KA 654-12-12  
August 1, 2013

**Subject:** *Response to Request for Additional Information dated May 10, 2013  
Air Construction Permit Application (0250020-035-AC)  
Tarmac America LLC; Facility ID: 0250020*

Three charts are provided below of NOx emissions for 1-hour average (lb/hr), 24-hour average (lb/hr), and 12-month rolling total emissions of tons per year.

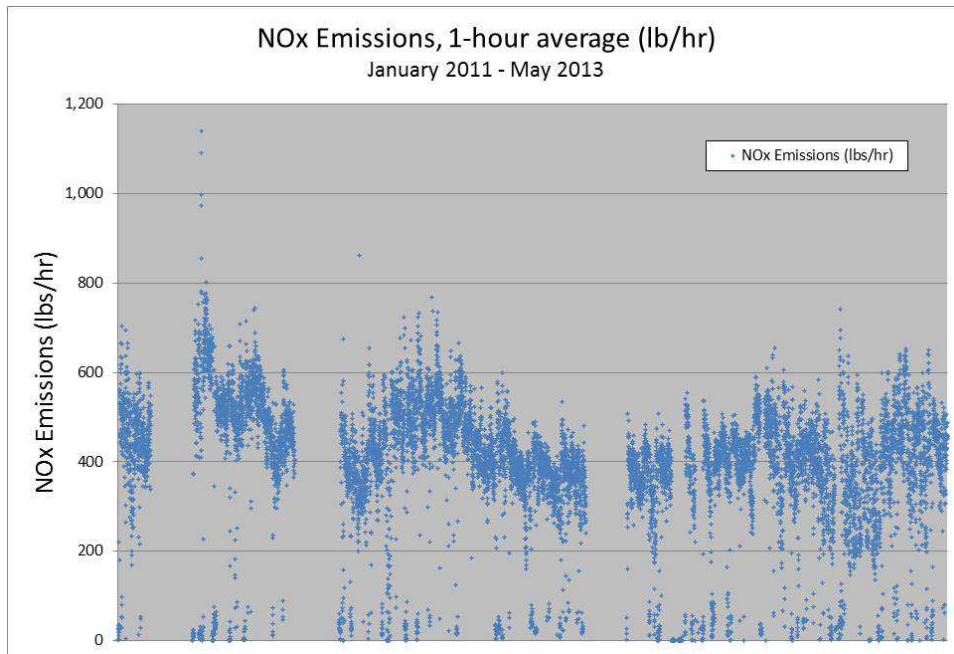
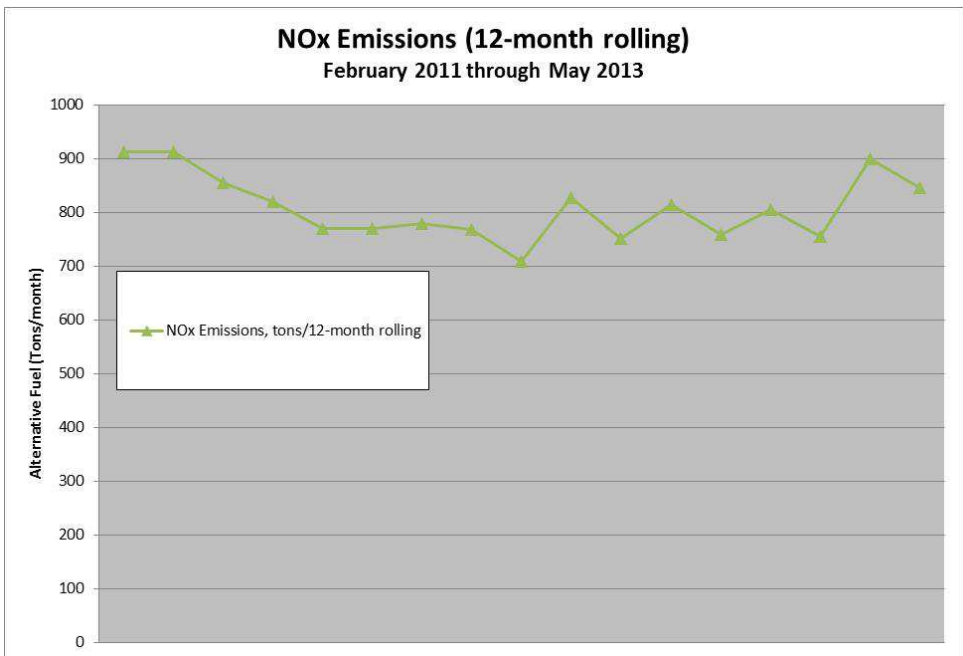
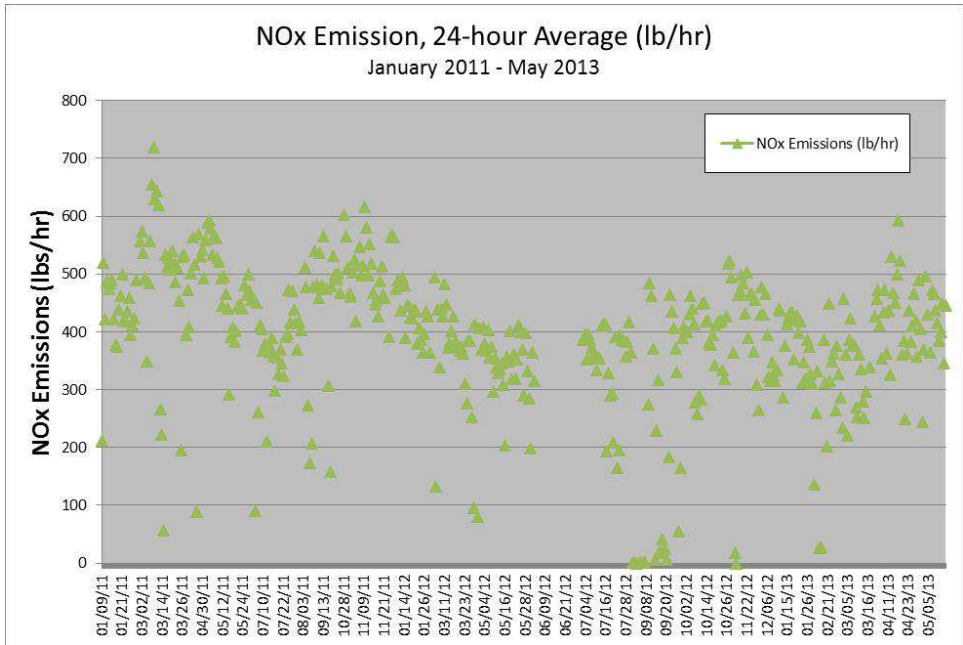
To evaluate this request, please submit a chart representative of the continuous emissions monitoring (CEM) for NO<sub>x</sub> (2 years representative period) including short and long term data. The summary chart example below is taken from the 2005 technical evaluation and preliminary determination (TEPD) for this pollutant.

Please provide reasonable assurance that the short-term emissions will not be exceeded.

One of the charts below shows the 24-hour avg lb/hr values of NOx from Jan 2011 to May 2013. The chart reflects the fact that the kiln has been up and down many times over the last two years (due to the economic downturn). However, given that when the kiln operates, the kiln must operate at least at 75 percent of capacity to ensure accurate control of the thermochemistry, the data also indicate short-term emissions are relatively constant.

Again, the kiln emissions of NOx are controlled through the kiln operation and not through an optional add-on control. NOx emissions should therefore not change if the 720 lb/hr emission limit is removed from the permit.
